# Addendum #1

Attn: Estimator	Date: February 21, 2024
From: Lisa Donahue, Project Administrator	Pages: 92 (including cover page)
Re: Bay City Public Schools	Project: 2024 SF BP 11 – Eastern HS at Handy MS
CC:	Proj. #: A23904

PROJECT TITLE  
 RENOVATION FOR BCPS:  
**BAY CITY EASTERN HIGH SCHOOL AT HANDY M.S.**

PROJECT NUMBER <b>2018040.16</b>	SHEET NUMBER
PROJECT DATE FEBRUARY 1, 2024	<b>A3.02</b>
CHECKED BY J.A.R.

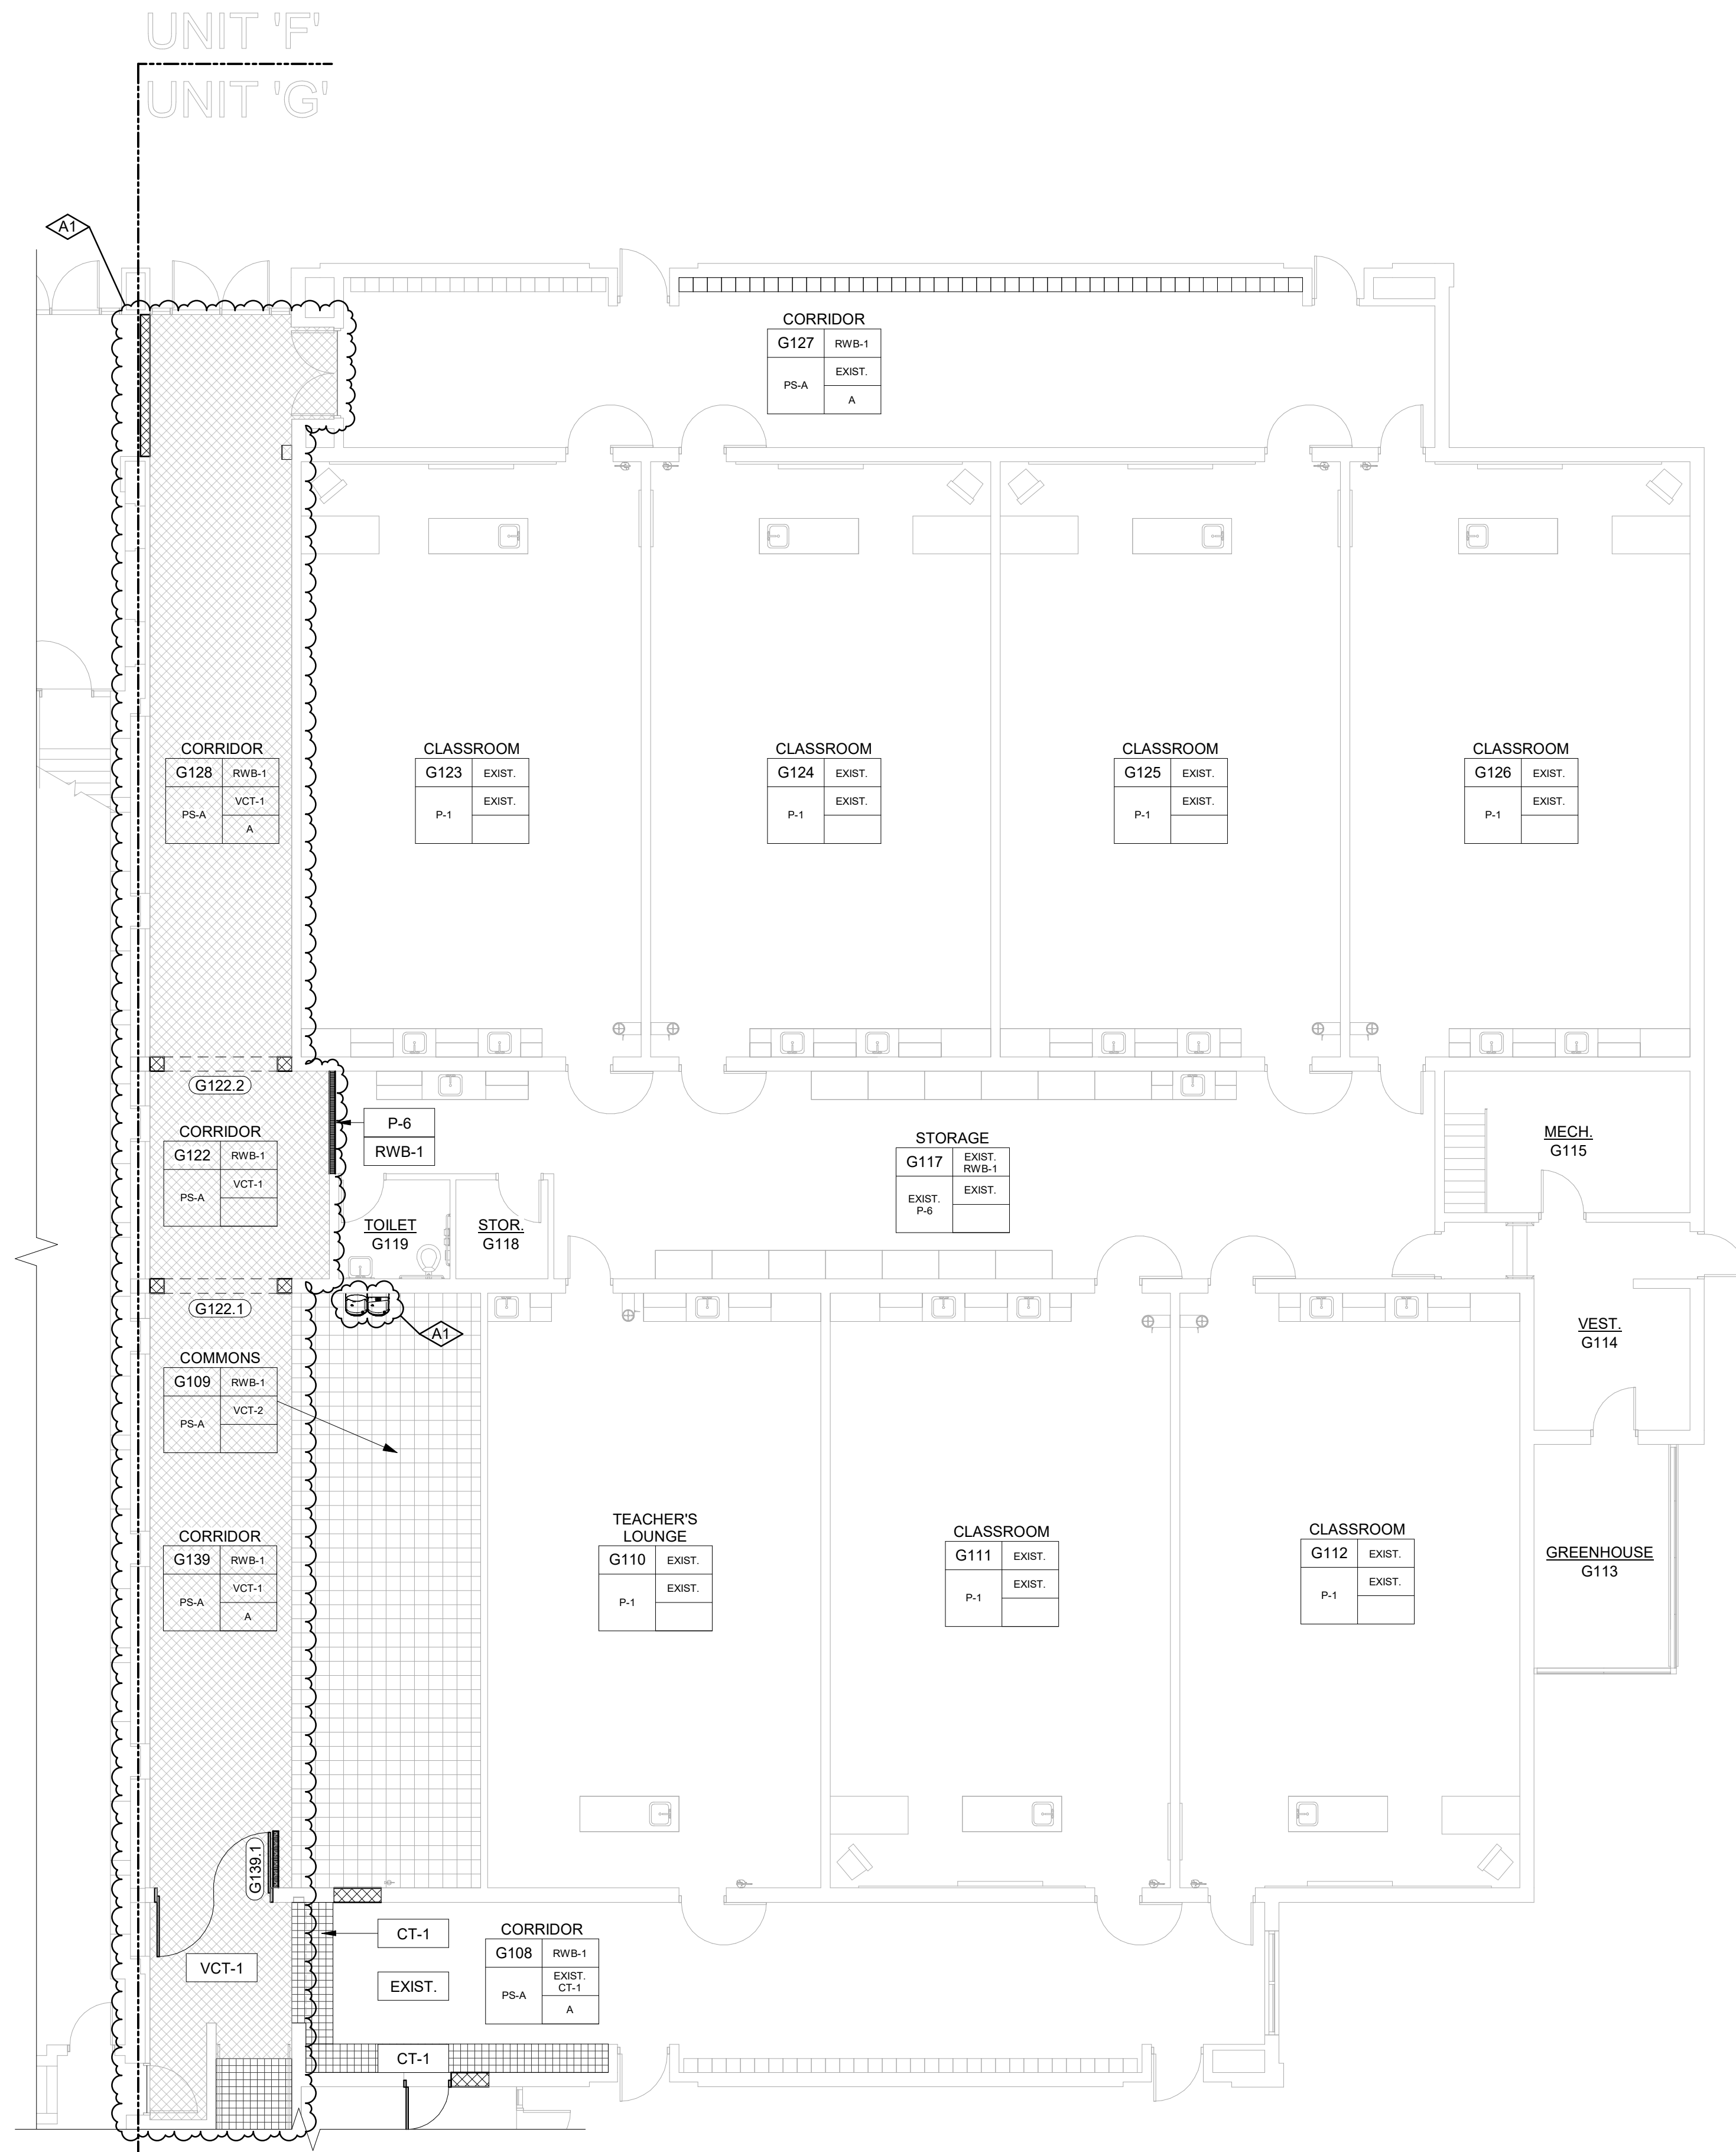
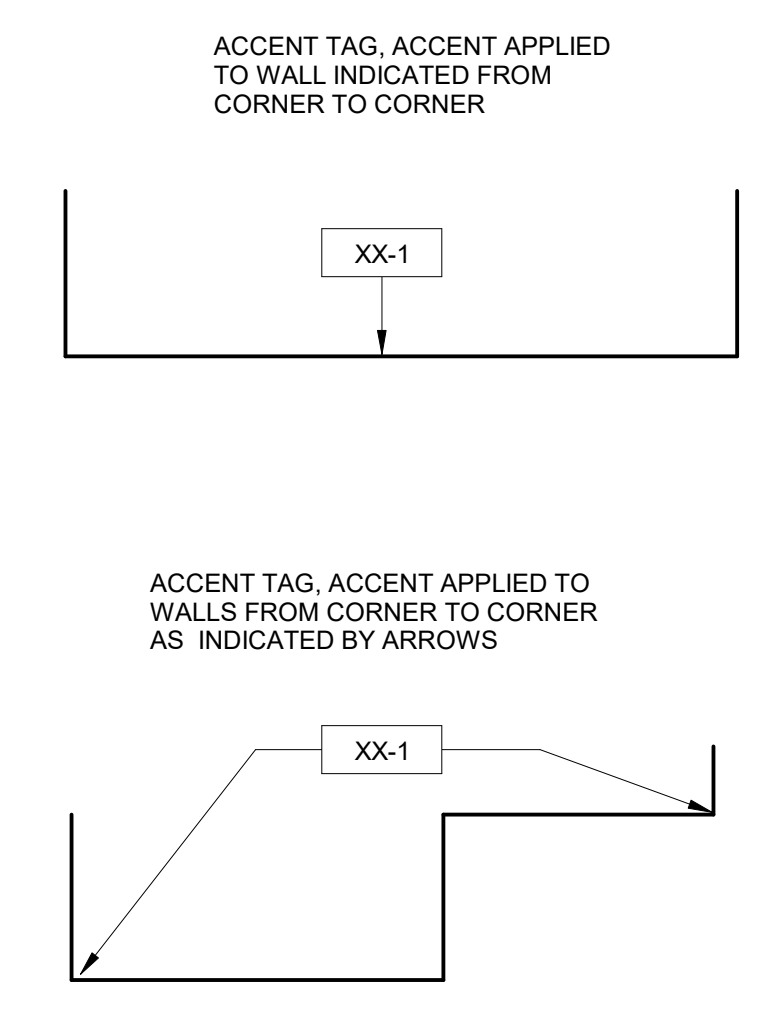
Item A10: Reference Sheet A3.01, A3.02 (Re-Issued)

- A. Added a hatch pattern to clarify floor material locations.

PROJECT NUMBER <b>2018040.16</b>	SHEET NUMBER <b>E2.03</b>
PROJECT DATE FEBRUARY 1, 2024	
CHECKED BY JWF

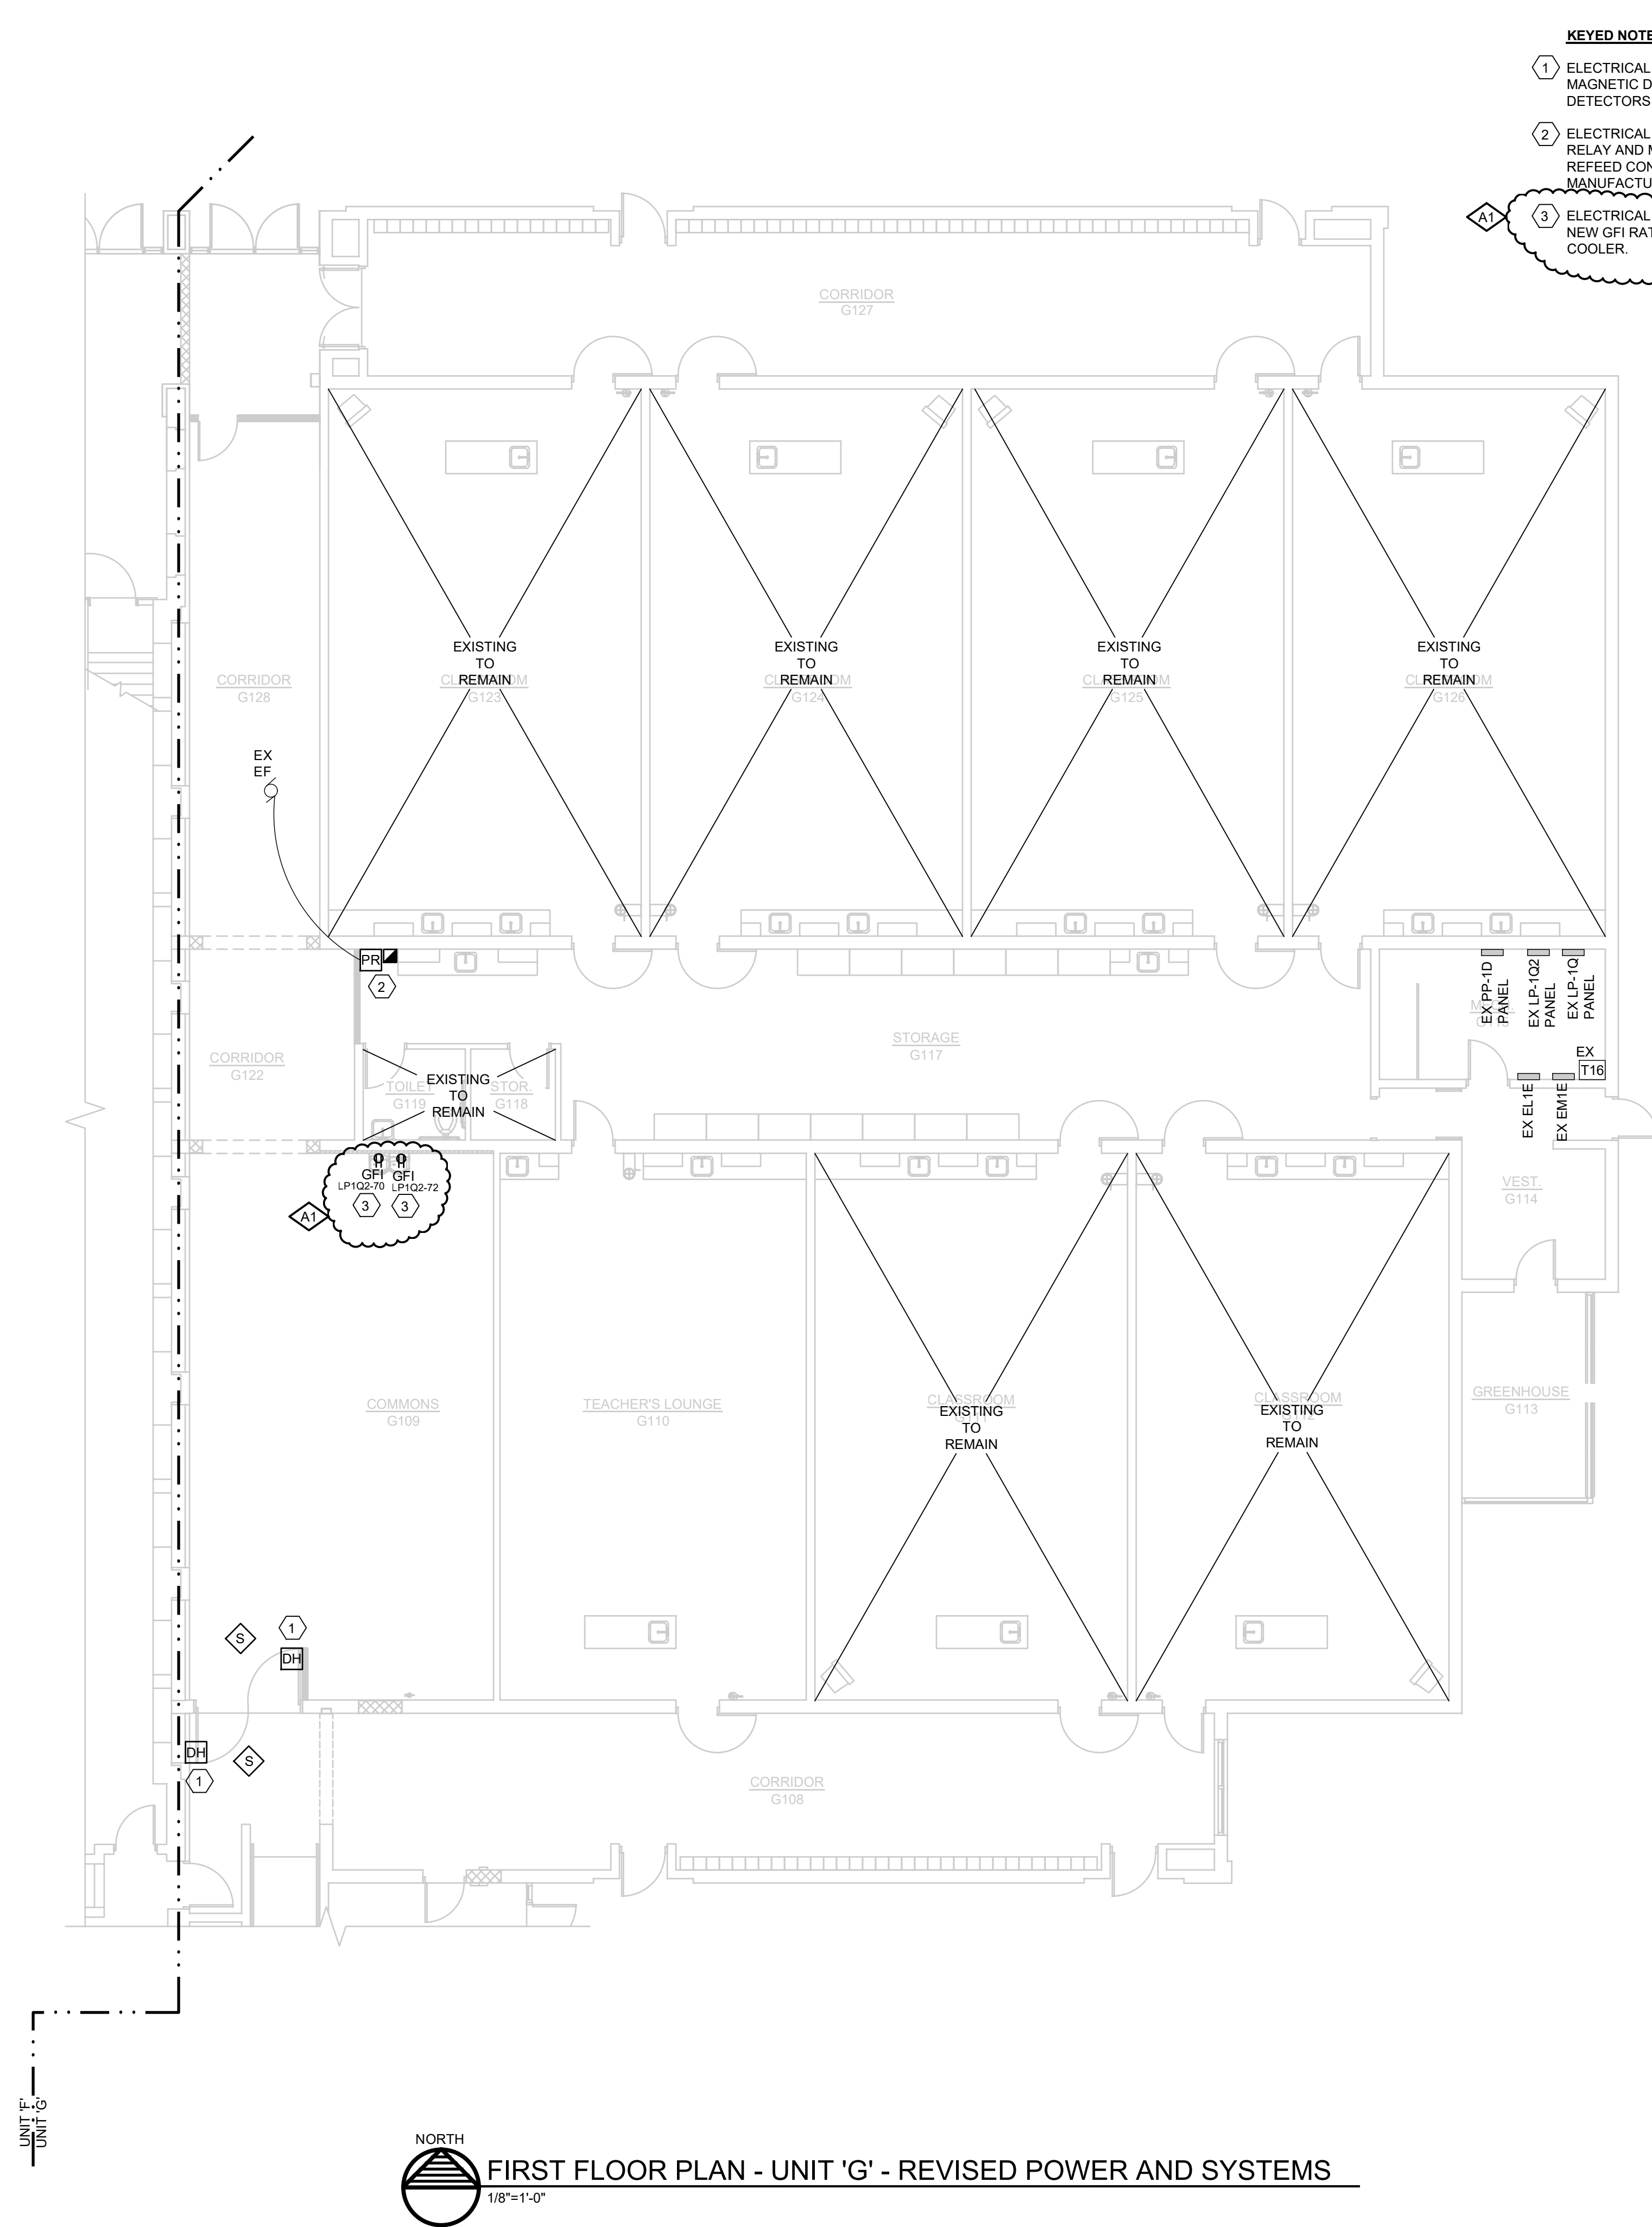
Item E1: Reference Sheet E2.03 (Re-Issued)

A. See receptacle location change.
